To Wayland Zoning Board of Appeals

From: John Sax - President of the Willow Brook Condominium Association

Date: March 11, 2021

Subject: Three Unresolved Issues in the Loker field project

Figure 2

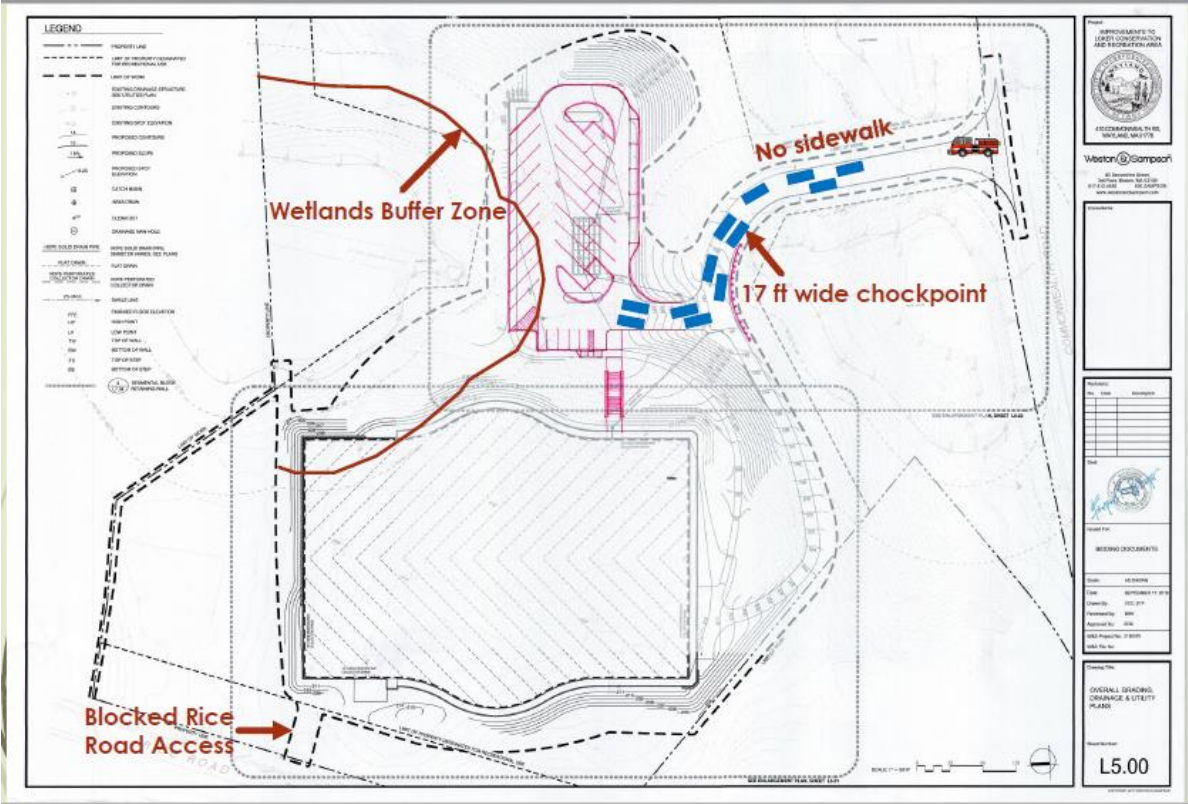
- There is still no sidewalk on the narrow access road making it dangerous for pedestrians at any time.
- As shown the Figure 2 below even a few cars on the access road will make it almost impossible for an ambulance or fire truck to get to the field or the parking lot.
- There is not enough room for cars going to and from the parking lot to move off to the side for emergency vehicles.
- Cars moving up and down the road must move to the parking lot to get out of the way of an emergency vehicle. This means cars coming down the hill will have to back up past the sharp turn to get out of the way. The likelihood of a fender bender accident or a collision with a pedestrian as drivers rush to get out of the way is significant enough to present a real danger.

As shown in figure 2 is that the field is so large it blocks the Rice road access to the property.

- The existing access from Rice road which currently runs all the way to the parking lot could become an emergency vehicle access road for the field and parking lot.

- That option is not feasible in the current design because the excavation needed to level the north west corner of the field means that the Rice road access will stop where the ground drops from the access road level to the field level.
